**Re: Rapiscan AIT System Radiation Survey Reporting**

**R-0646-1 Addendum  
(Documentation Errors)**

Product Name	Secure 1000SP (Single Pose)
Serial Number	<b>S50951004</b>
Radiation Emission Measurement	Radiation Survey Dated: 05/20/2010
RSO Initials

**1. In Beam Dose Measurement: Survey Table. 1**

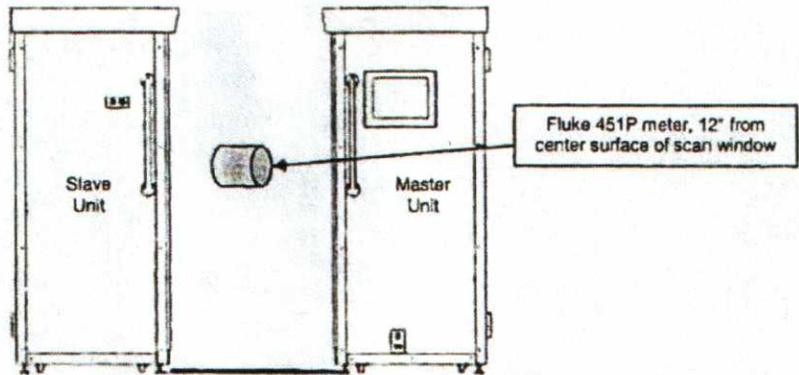
1. No value indicated for background radiation. Typical values range from 7uRem/hr to 13uRem/hr at sea level. Note: Absence of value has no adverse impact on calculations.
2. Technician indicated scan time as 7 seconds. Correct scan time is 3 seconds.
3. TABLE 1: Incorrect presentation of data in Column 3 for Measured Exposure. Indicated values are 31uR and 36uR. Corrected values are 3.1uR and 3.6uR. The values were corrected by technician when calculating Effective Dose.
4. TABLE 3: Incorrect presentation of data in Column 6 for Dose Equivalent. Indicated value is .18 uRem. The correct value should be 1.8 uRem.

The service technician should attend refresher training.

The corrected data indicates this system was operating within expected parameters. No re-survey is required for this system.
